## **ADDENDUM #4**

### **Rye City School District**

#### **Osborn Elementary School**

#### **Midland Elementary School**

Approver  
SEAL & SIGNATURE DATE: 09/25/20  
PROJECT No: 9200  
DRAWING BY: Author  
CHK BY: Checker  
DWG No: A3-204

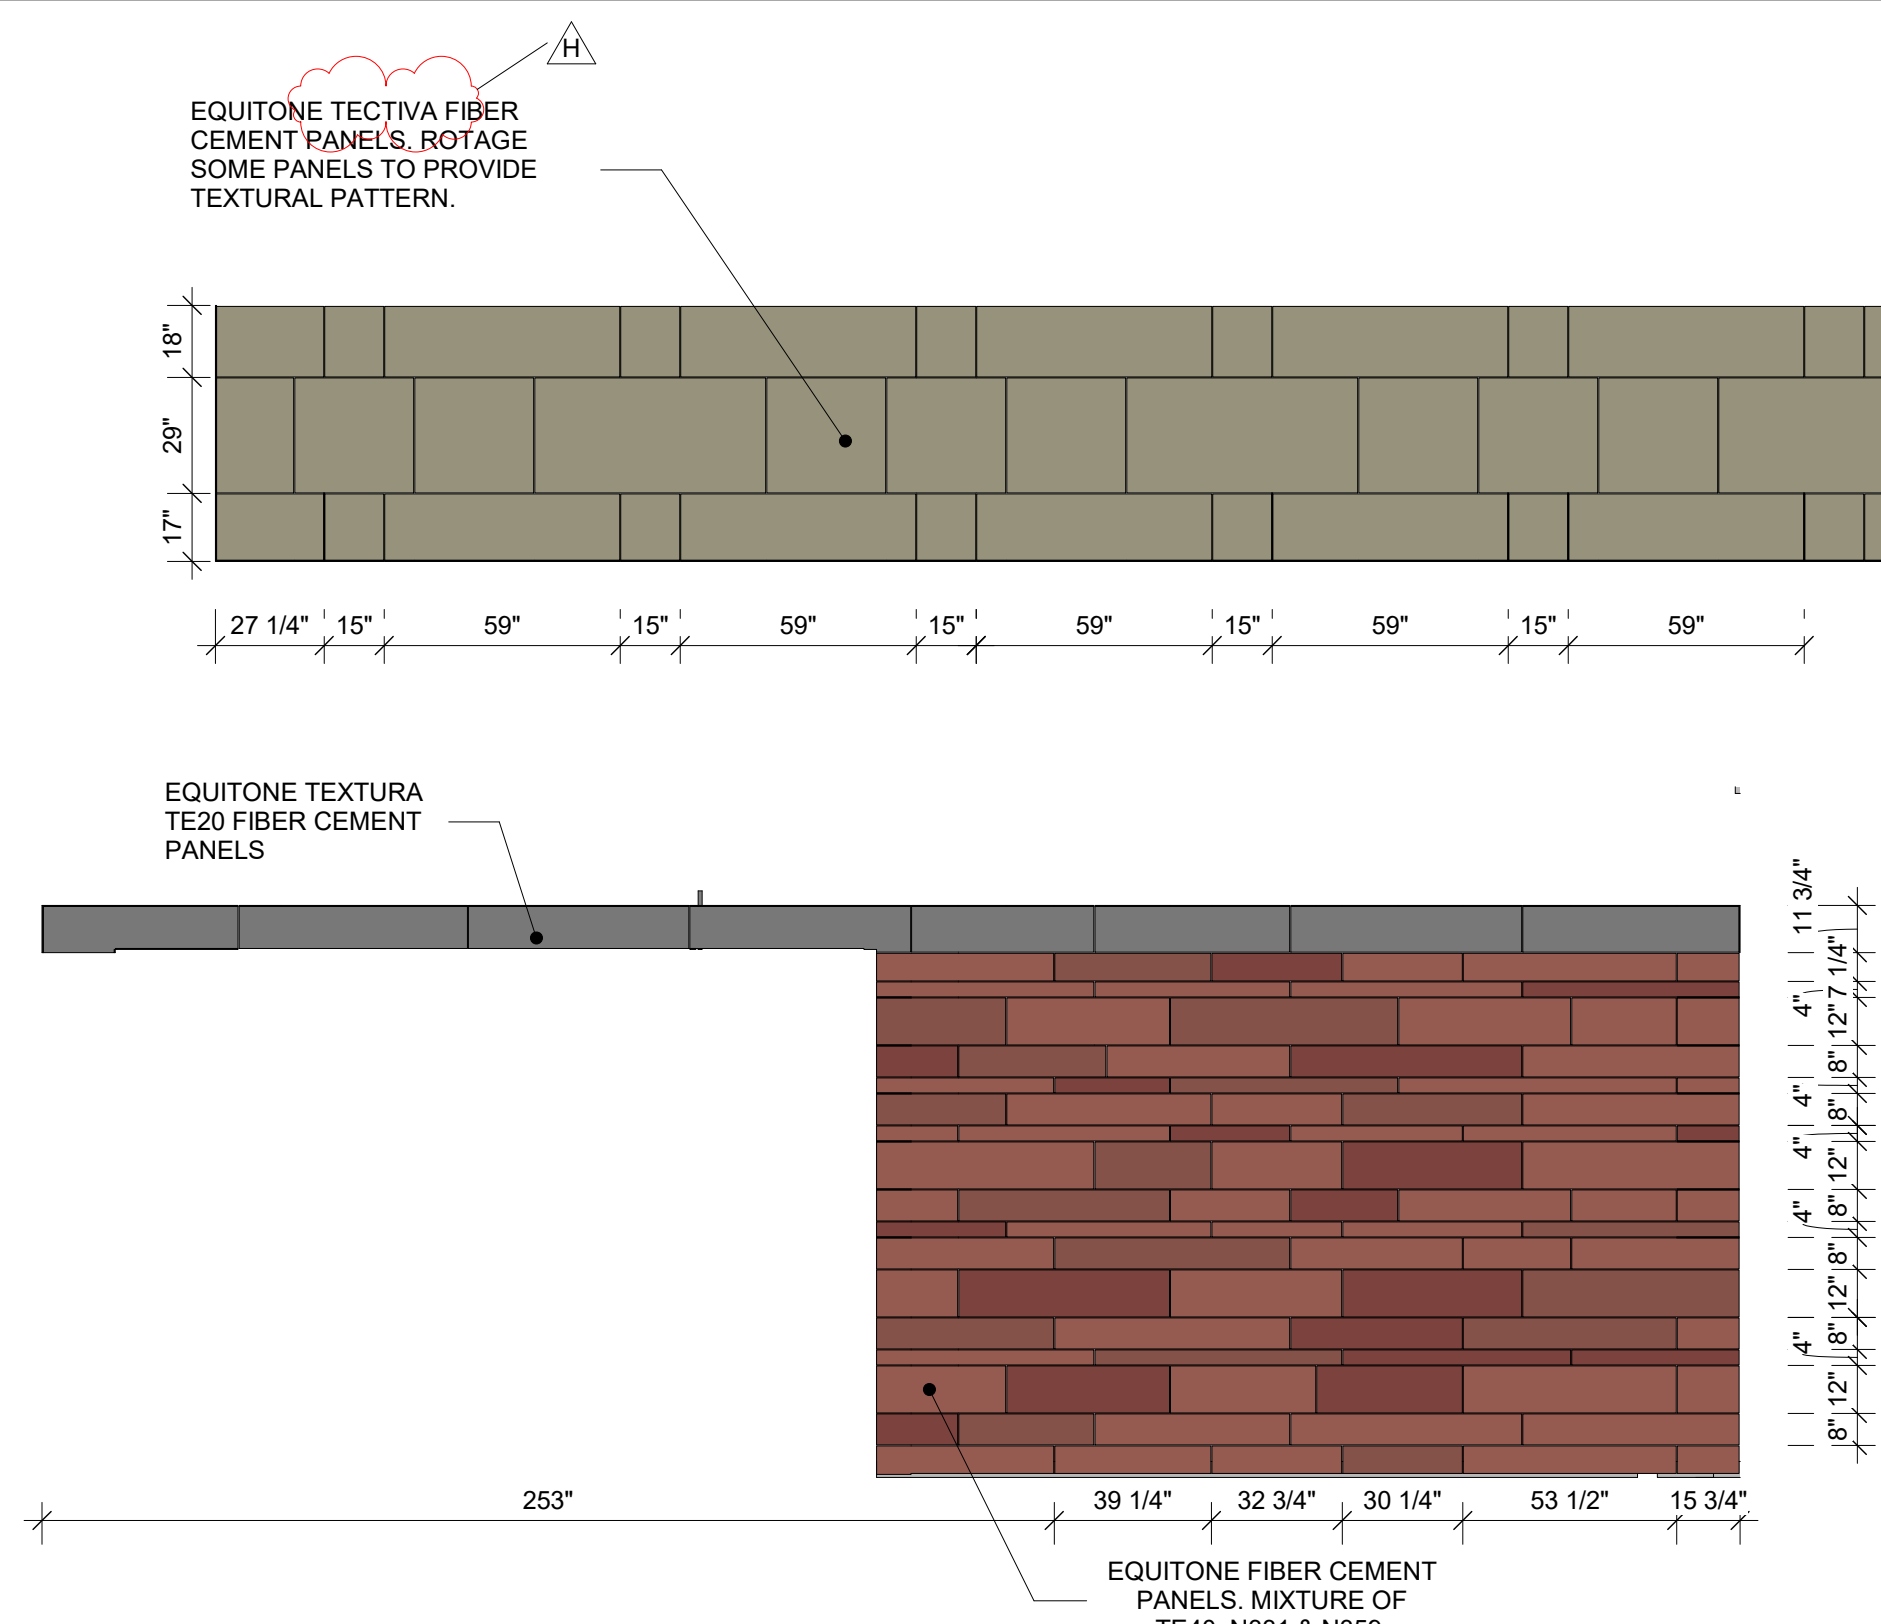
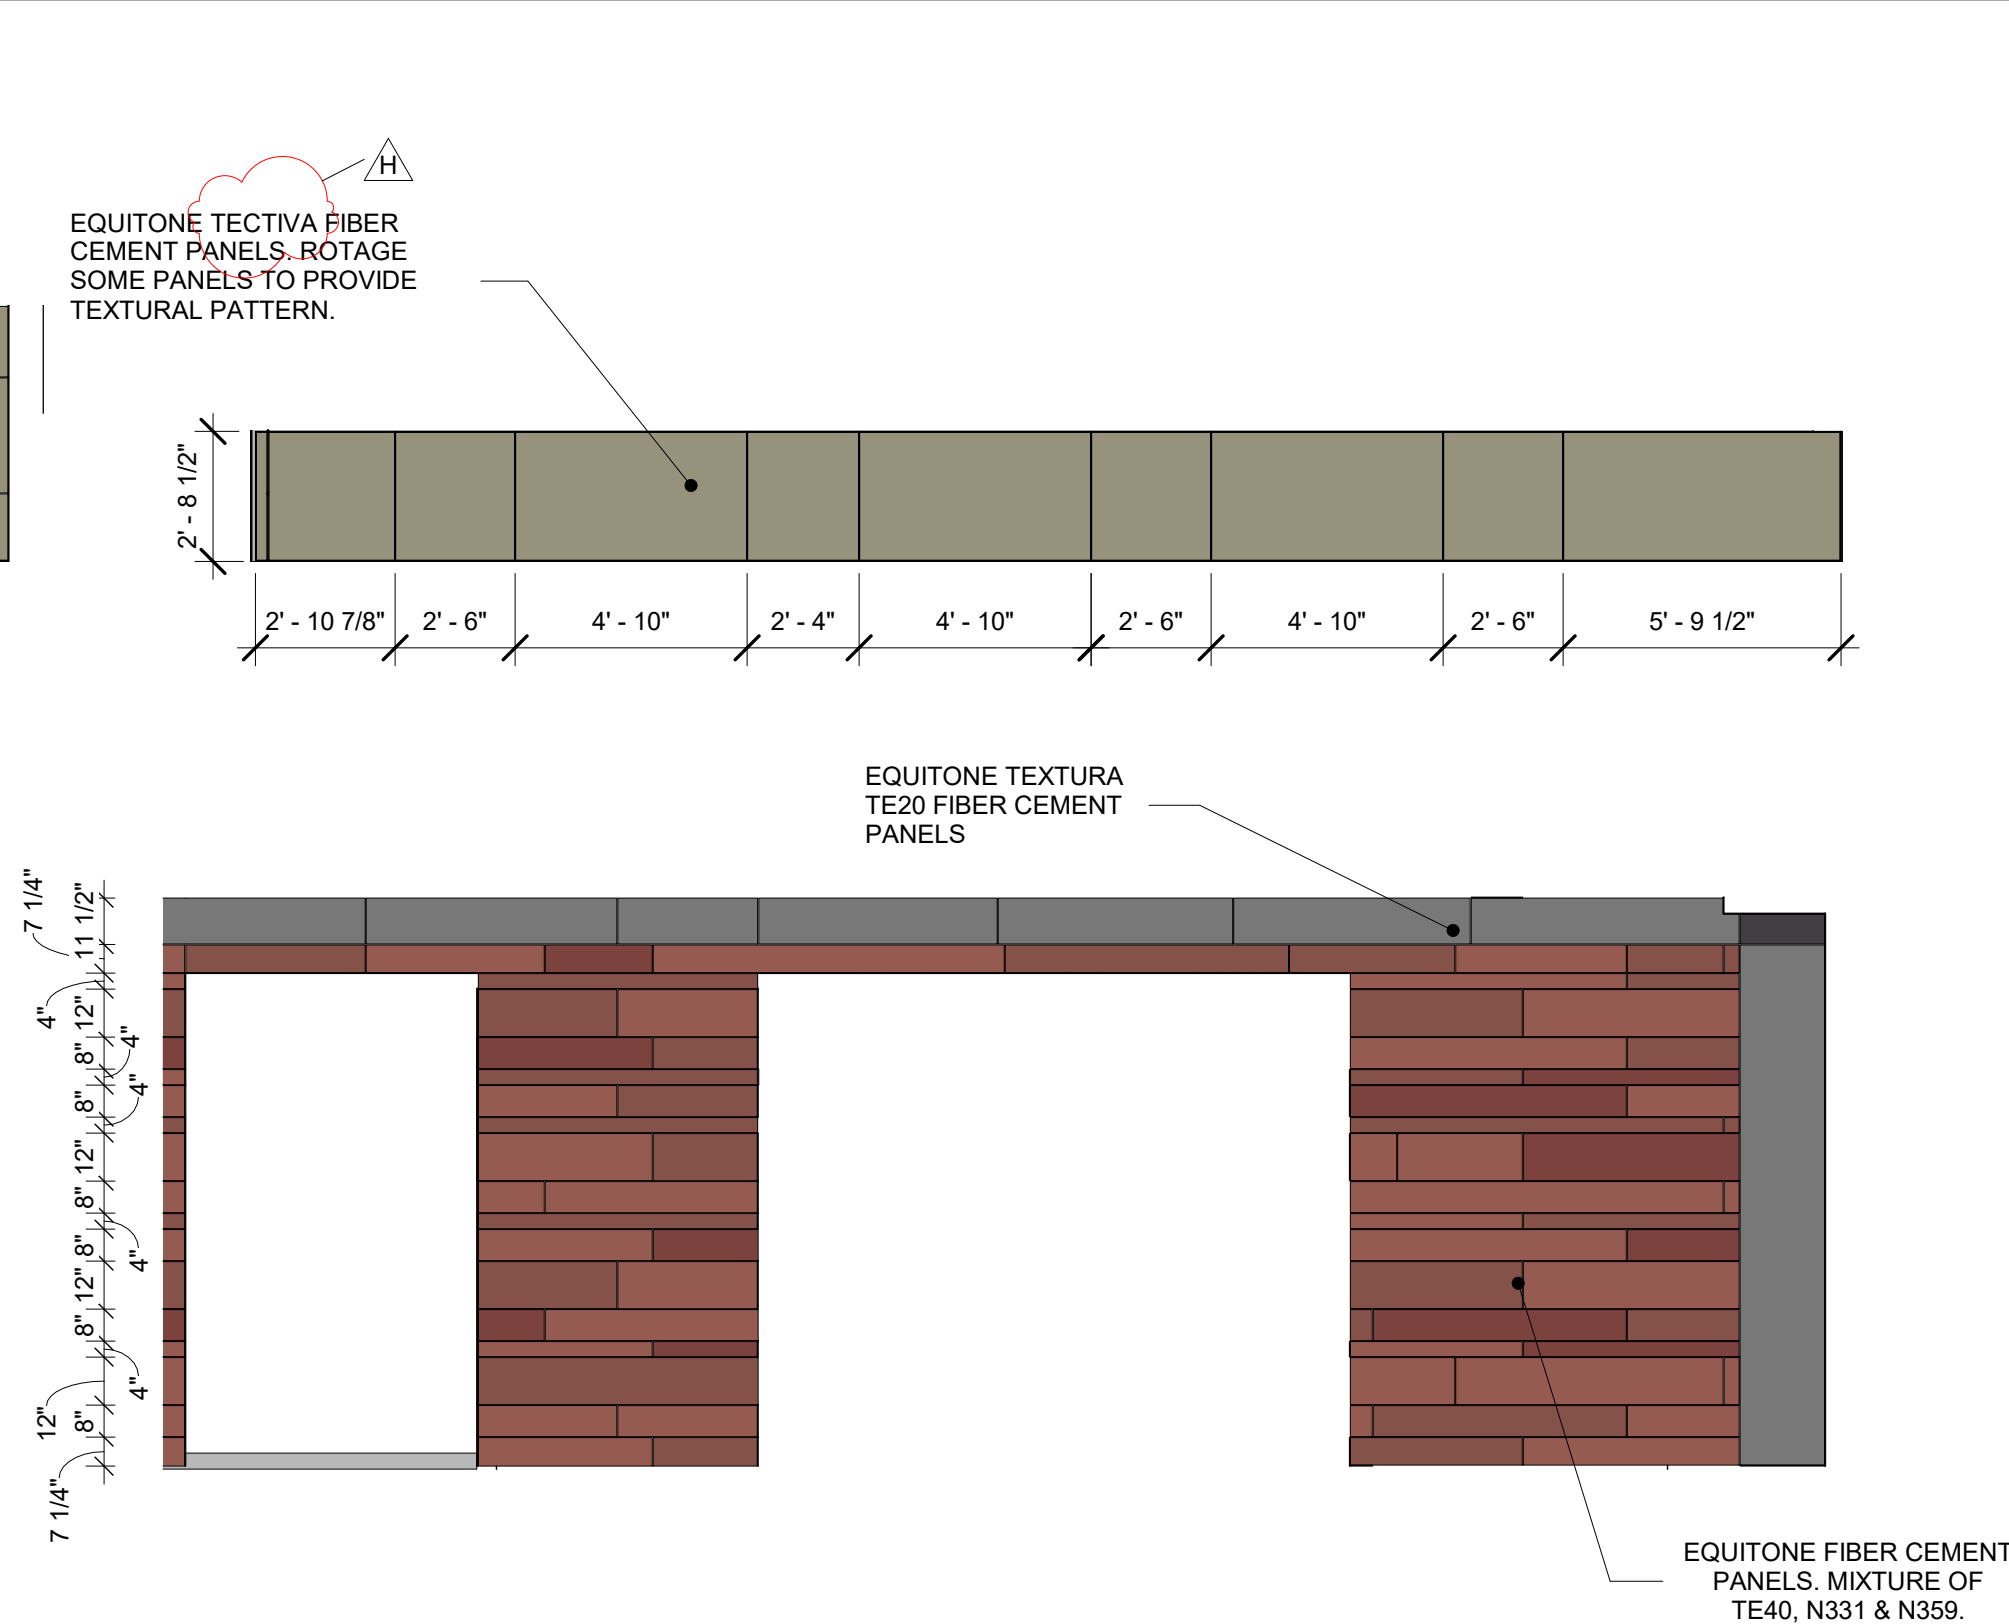
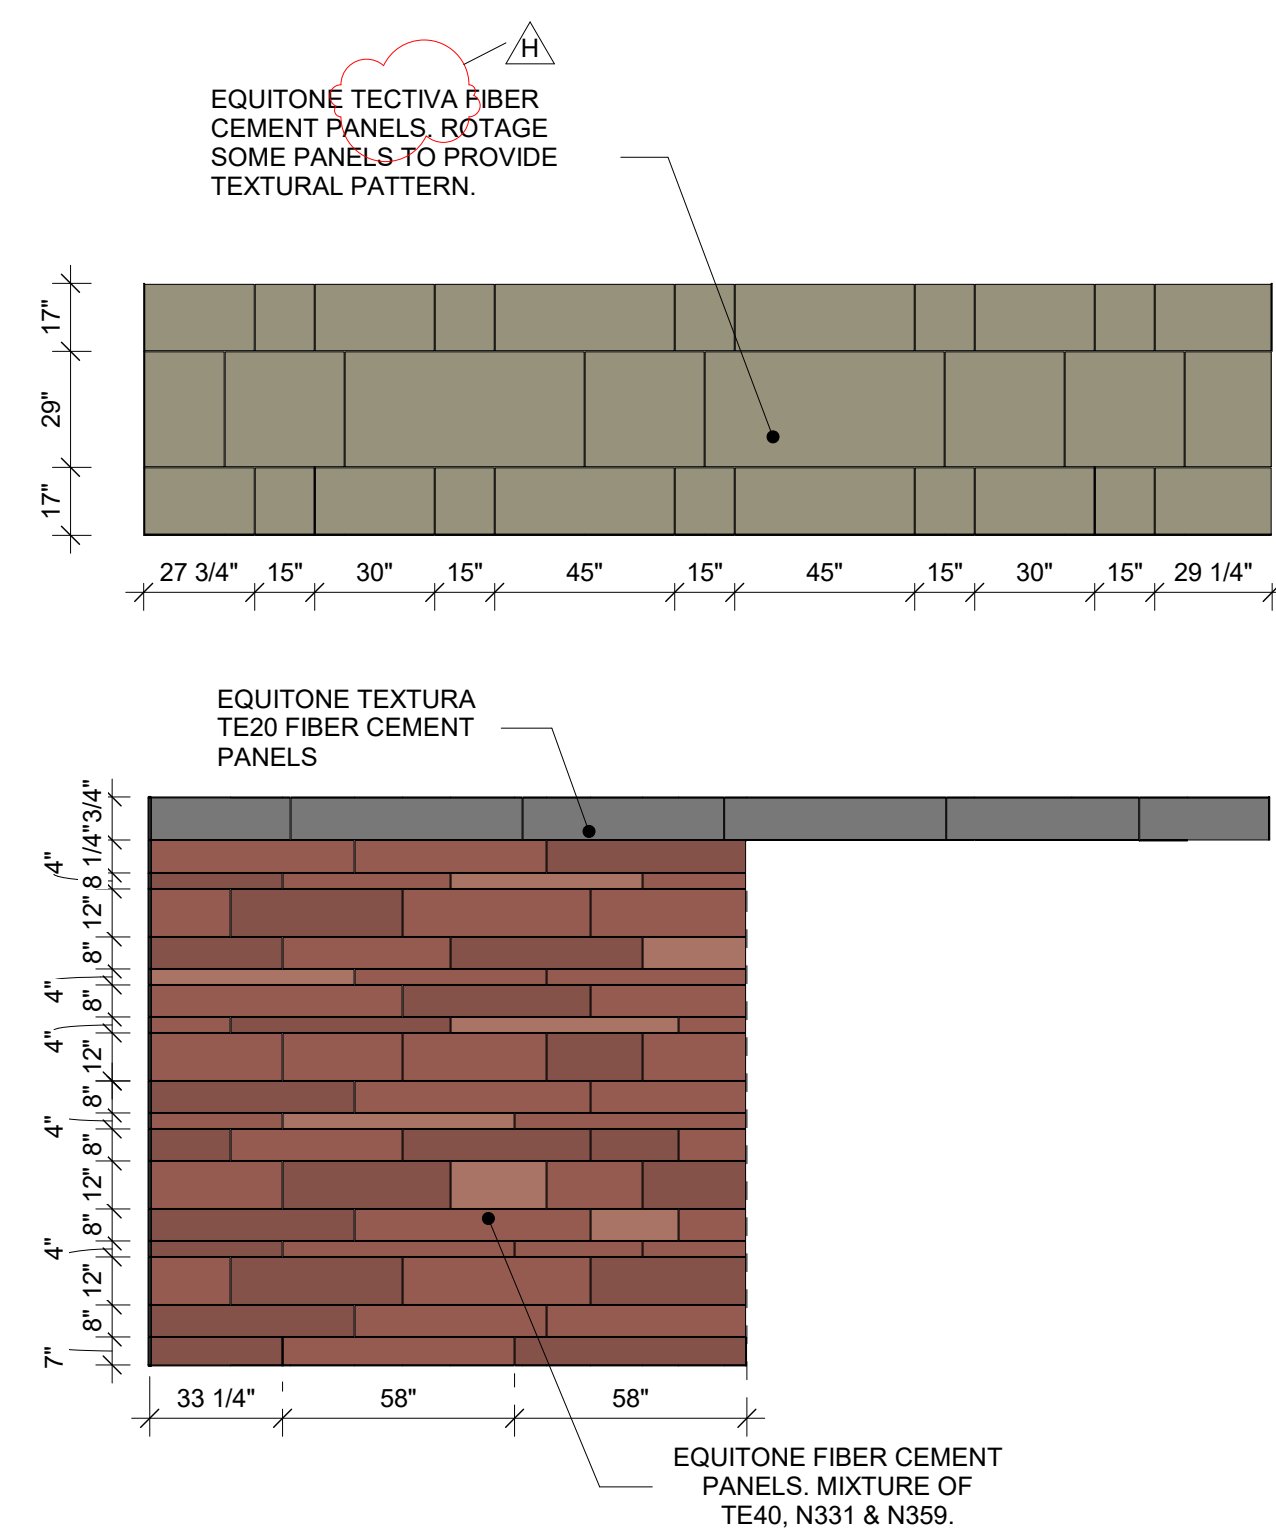
4. **Question:** Equitone fiber cement product is no longer available. Please advise.  
**Answer:** Only equitone materia line is discontinued. Drawings updated and included in this addendum to show equitone tectiva in locations where materia was previously indicated.
